## STAFF REPORT

APPLICATION SE 2010-DR-002

**PROPOSAL:** Sewage Line Odor Abatement Facility

# POTOMAC INTERCEPTOR LONG TERM ODOR ABATEMENT PROGRAM SITE 31 SPECIAL EXCEPTION PLAT / 2232 REVIEW

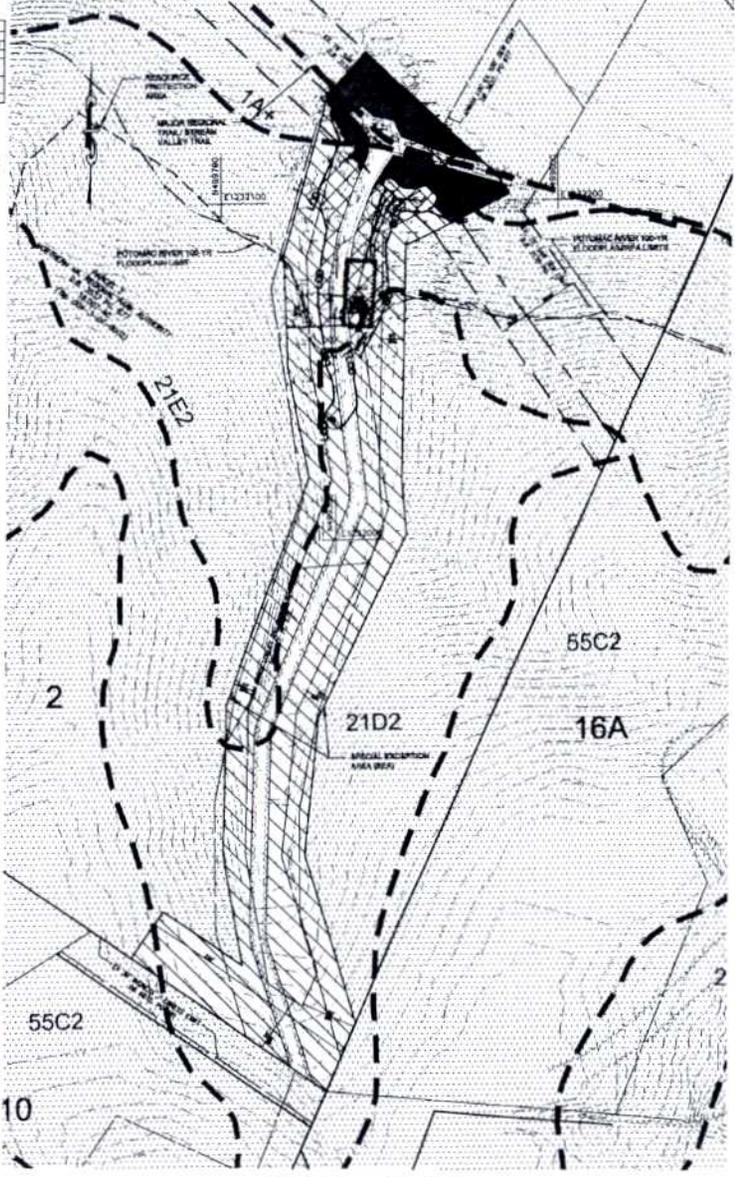
Sheet 3 of the SE Plat incorporates existing vegetation information. The notes provide detailed information regarding tree preservation and protection measures to be implemented prior to and throughout the land disturbance and construction phases of the project. The notes indicate that the applicant is working closely with the Urban Forestry Management Division of DPWES. Staff encourages the applicant to look for opportunities to replace native tree species similar to those specimens which will be lost because of the sewer line project.

**Resolution:** The applicant has since modified the plan to show provide clarification on the EVM, including tables to identify the primary species and a statement about the health and condition of the existing vegetation. Upon review of these requested items, UFM had no further comment. Therefore, this issue is addressed.

**RESPONSE:** The existing vegetation map sheet SE-003 has been updated with the primary species and general health and conditions added to the existing vegetation map legend descriptions for each forest tree canopy type.

**SPECIAL EXCEPTION PLAN**  
SCALE: 1"=30'

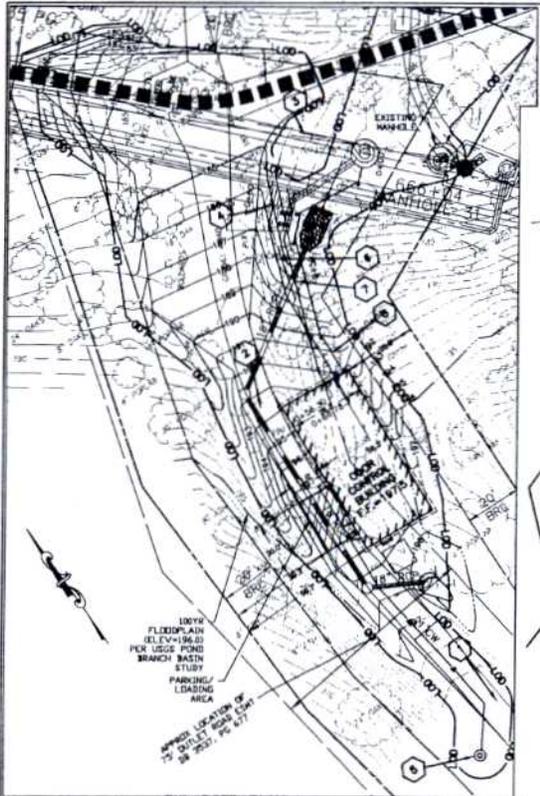
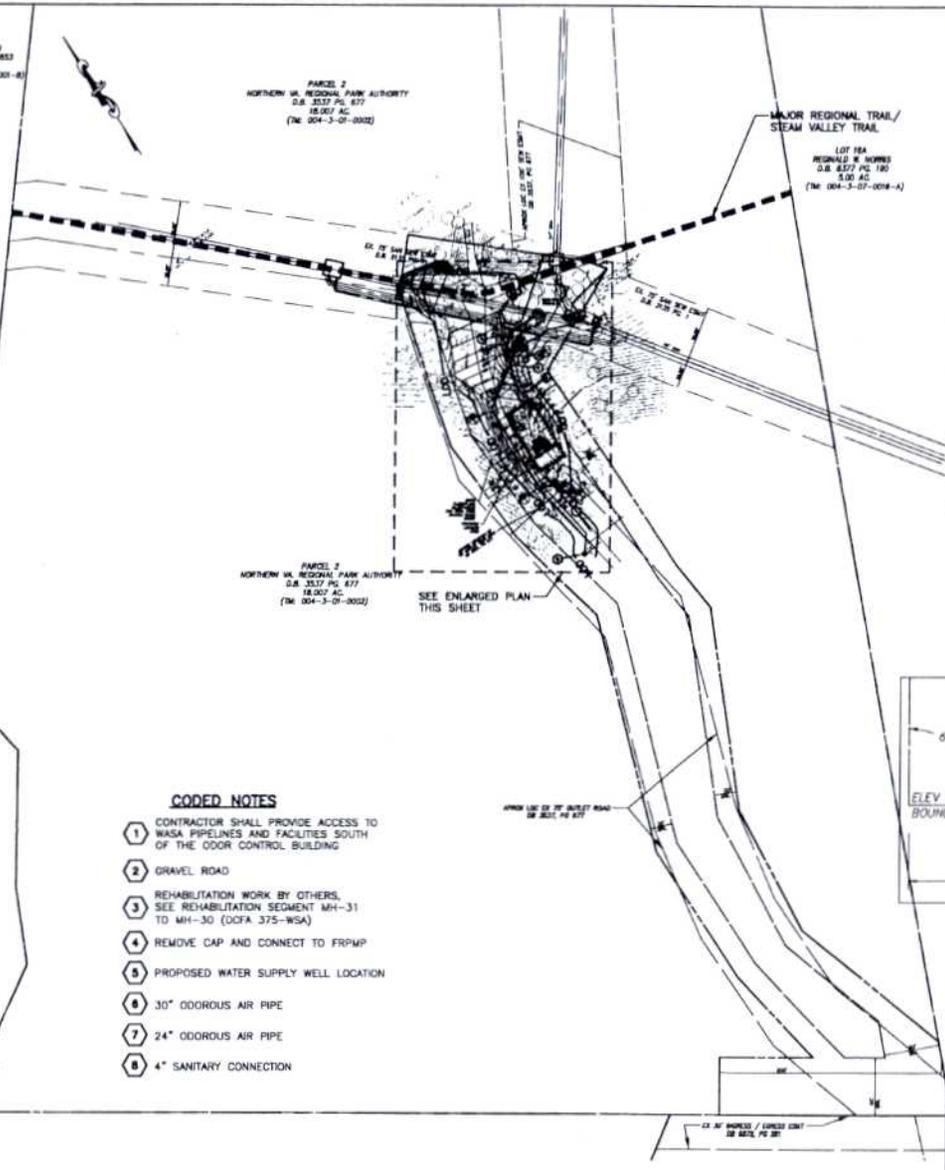
Clarification on the finished floor elevation (FFE) for the proposed structure was needed. Sheet 4 of the original SE Plat showed two different FFEs. The applicant must provide a FFE above the Potomac River Floodplain water surface elevation, which is 196.0 ft.

3. **Comment:** Section 2-905 of Zoning Ordinance requires the applicant to state why there are no other feasible options available to achieve the proposed use (paragraph 7A). The applicant's statement for this requirement has been provided in a memo; statement should appear in the plat. In the memo the applicant states a location was chosen that would be close enough to the interceptor to allow smaller equipment yet "... provide a finished floor above the Potomac River Floodplain water surface elevation." The floodplain elevation is 196.0 feet at this location. Sheet SE-004 shows two different finished floor elevations. The enlarged plan shows a finished floor elevation of 197.5 feet which is above the floodplain elevation. The Angle of Bulk Plane diagram, however, shows a finished floor elevation of 195.5 feet which is below the floodplain elevation.

5. **Comment:** Section 2-904 requires the extent of the proposed fill to be included in the application. An earthwork plan is now included on sheet SE-004. The rip-rap to be placed at the downstream end of the storm drain diversion is not included as part of the fill area.

ZO 2-904 requires the extent of the proposed fill to be included in the application. The fill area cited in Note #4 does not seem to be up-to-date. The 4083-cubic-yard volume cited in the Earthwork Table on Sheet SE-004 seems to reflect the current design.

The applicant has since modified the plan to provide clarification on the FFE for the proposed structure. It is 197.5 ft, which is above the floodplain water surface elevation. This issue is addressed.

**RESPONSE:** The angle of bulk plane diagram has been revised for the appropriate finished floor elevation and the memo response has been added as Floodplain Regulation Note #10 on Sheet SE-004.

**RESPONSE:** The rip-rap is actually in an area of cut and not fill, the area has been revised and appropriately labeled on the earthwork plan on sheet SE-004.
